Building Code of Australia 2019 Amendment 1

Report for BCA Compliance – SSD Application Stage

PROJECT NAME: Wee Waa High School

PROJECT NUMBER: GDL210338.1

00	0	STATUS
1		
		DRAWING TITLE
2388		Ground Floor Furniture Layout Plan

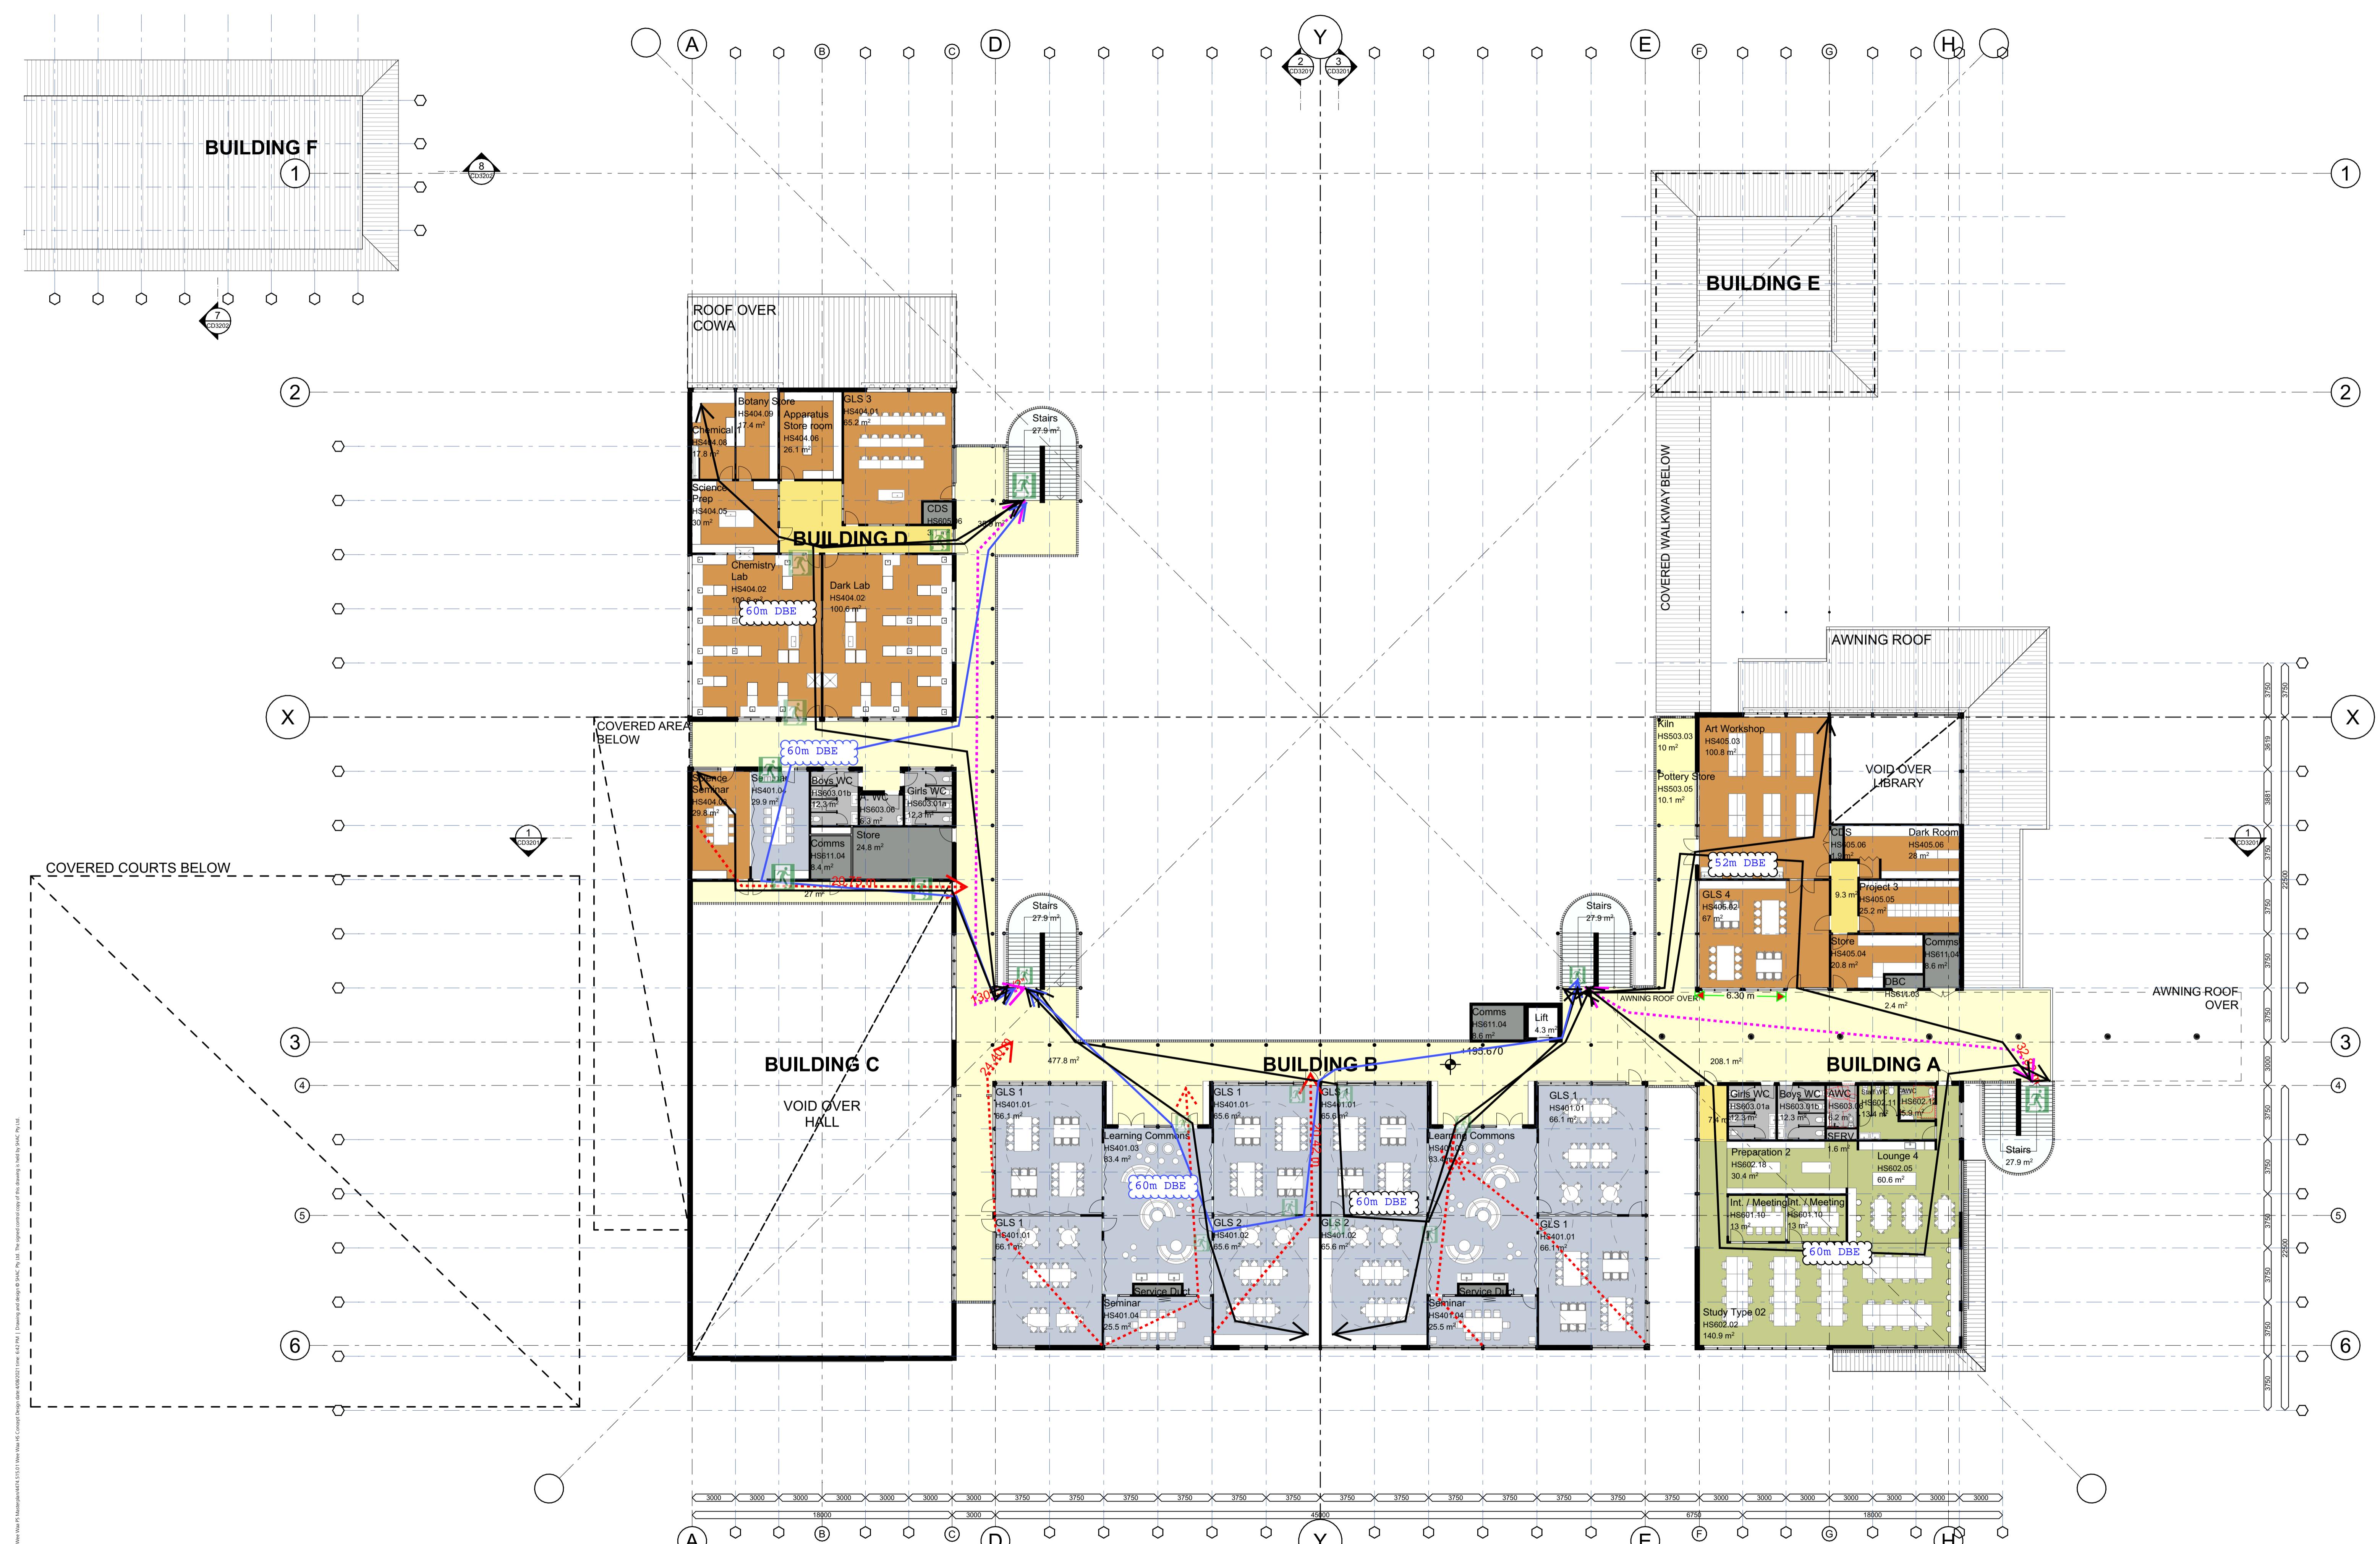
Note: See attached TD Plans as requires egress through rooms & classrooms – exit sign and no lockable doors required.

Clause	Reference	Comment
D1.4	Exit travel distances	
✓	No point on the floor must be more than 20m to an exit or a point in which travel in different directions to 2 exits is available, in which case, the maximum distance to 1 exit cannot exceed 40m.	This is complied with, however there are some areas that have egress travel through classrooms, meeting rooms etc. <u>Note: Exit sign detail to indicate egress paths and Door Latching to ensure no lockable doors in direction of egress.</u>
Clause	Reference	Comment
D1.5	Distance between alternative exits	
✓	To be no less than 9m or more than 45m in a Class 2, 3, and 9a, or 60m in all other classes, uniformly distributed with access to 2 exits if required and not converge so they become less than 6m apart.	The building as designed / indicated complies with this clause.
D1.6	Dimensions of exits and paths of travel	
CR	<ul style="list-style-type: none"> Height – minimum 2.1m or 2.4m for other areas: doorways 1980mm Width 1m minimum clear width Width change based upon populations – generally for populations up to 100 persons require 1m of egress, up to 200- 2m and then varies according to use over 200 people per floor / storey depending on the use/classification. Door width clear opening size of a minimum 850mm (AS 1428.1-2009) Egress dimensions are not to diminish in direction of travel. <p><u>Note:</u> see also re number of exits for certain uses Clause D1.2 as may require additional exits no matter the population of the storey.</p>	Further review of the developed detailed design is required for absolute confirmation.
